## Further objections in respect of the Development Application for 23 Hay Street Collaroy (DA2021/1824)

Submitted by Simon and Emilie Burns, [REDACTED]

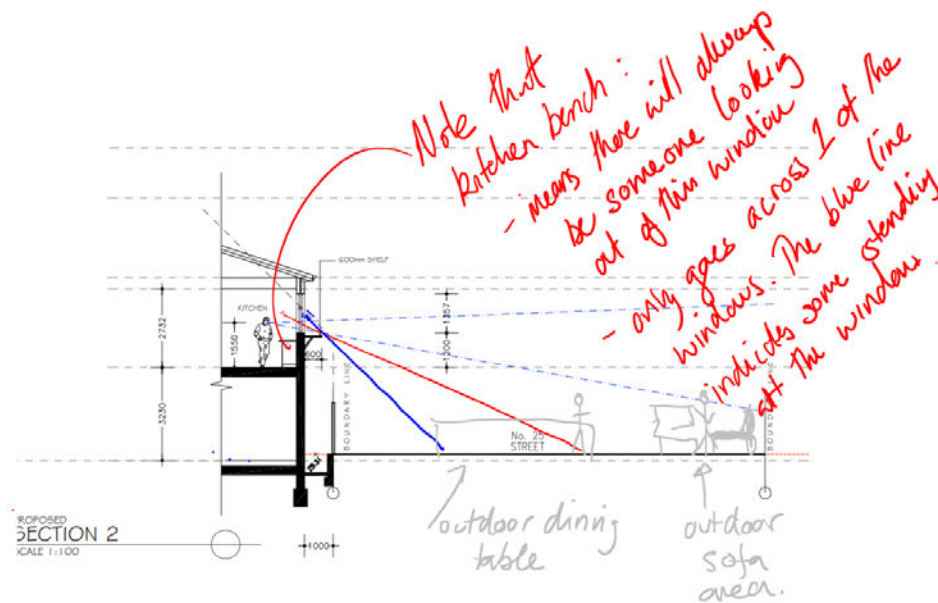
The proposed inclusion of a 600mm shelf under some of the north facing windows do not address in any way the privacy and overlooking concerns previously raised in our earlier objection. In addition to this, the diagram included on the last page of the masterplan is entirely misleading as it:

- Only draws sight lines based on a small stature person, well under average male height
- Only draws sight lines when that small stature person is standing well back from the window, not when they are standing at or near the window.
- Finally, it incorrectly draws the sight line not at the edge of the shelf.

Further, it does not at all appreciate that the proposed kitchen window looks directly into the current bedroom window of 25 Hay Street.

Please see below for corrected diagram addressing these issues. As you can see from the below, the shelf provides no privacy protection at all – and overlooks our dining area and sofa area.

The only way proper privacy can be achieved is by removing the windows or including only high level windows to allow in light, and / or including fixed shutters or screens that prevent the overlooking (note that these should not be moveable louvers). In addition, increasing the set back so that the building is compliant with side envelope requirements and inclusion of vegetation to soften the bulk and scale. For clarity, these types of protections are needed for all viewpoints from the norther side of the building, including upper level windows and balcony and middle level balcony and external staircase, as well as the staircase the entire way down the northern boundary.
